IREDELL COUNTY HEALTH DEPARTMENT

IMPROVEMENT PERMIT / AUTHORIZATION TO CONSTRUCT / OPERATION PERMIT / EXISTING SYSTEM INSPECTION

PERMIT# 136529 PIN# ~~4544 48 5449~~ 4644 48 3156 ✓ DATE 7/21/06

SUBDIVISION WESTVIEW RESERVE BLOCK/ SECTION — LOT 1 LOT AREA 1.147 SITE CLASS. PS DESIGN FLOW 480 L.T.A.R. .3

INITIAL SITE SKETCH

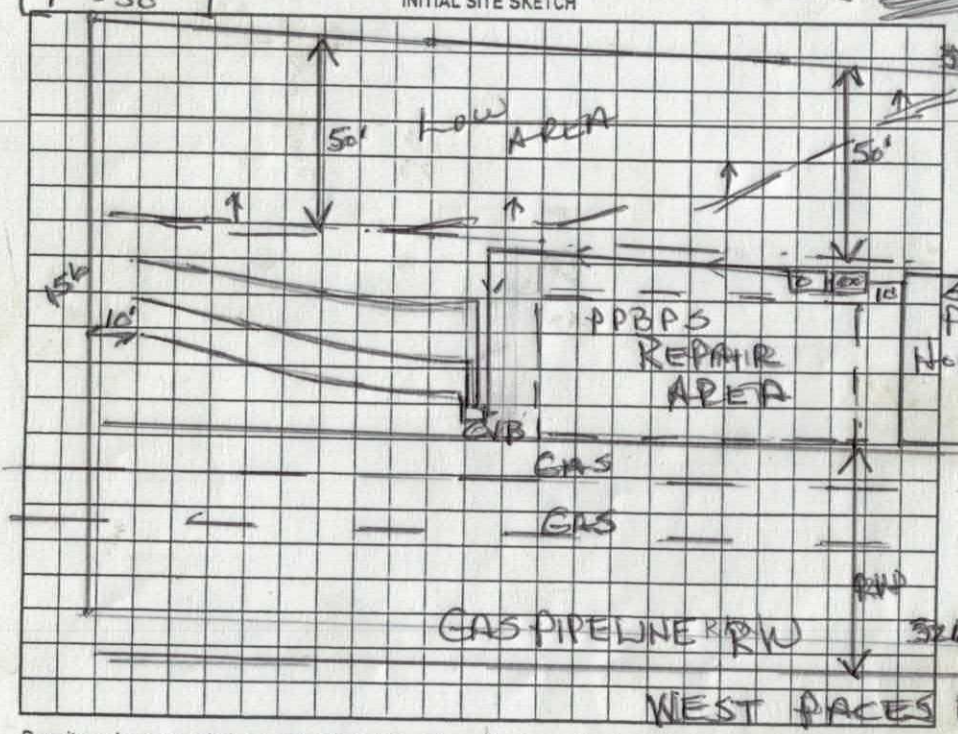
Comments:/Conditions: Earth Berme must be removed and earthen cover on soils for Compaction before AC will be issued. Berme covers repair area most. House location CANNOT BE shifted in any direction. There will be no room for an Swimming Pool. SYSTEM APPEARED TO BE WORKING
